DRH 07 00393

Proposed Addition
West Elevation
scale 1/8" = 1'-0"

DRH 08 00256

EAST ELEVATION
scale 1/8" = 1'-0"

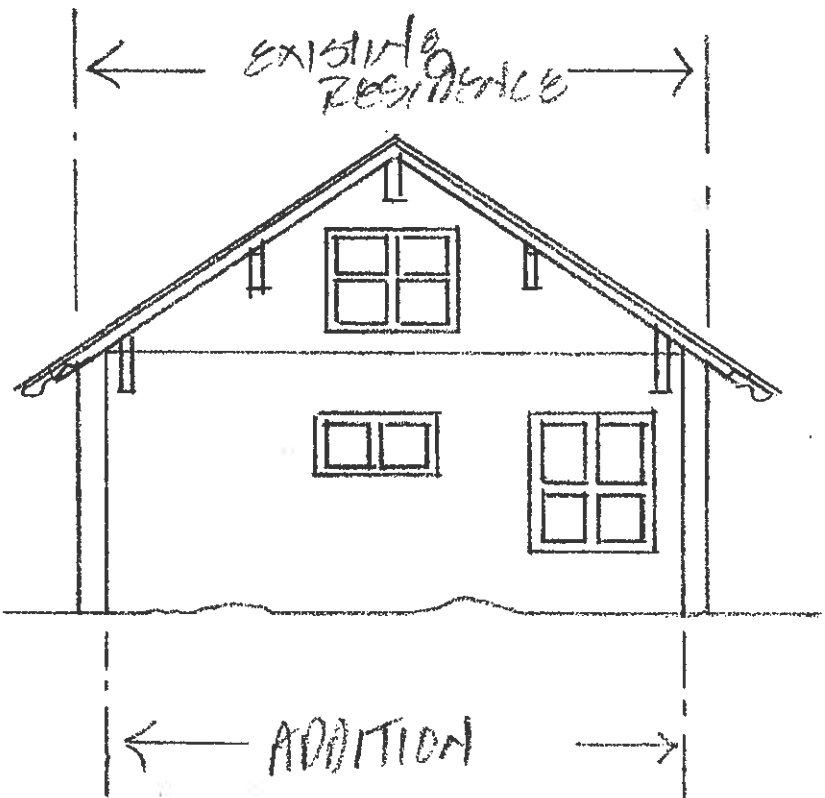
NOTE: Redline
screen & open porch
return posts to match
period details
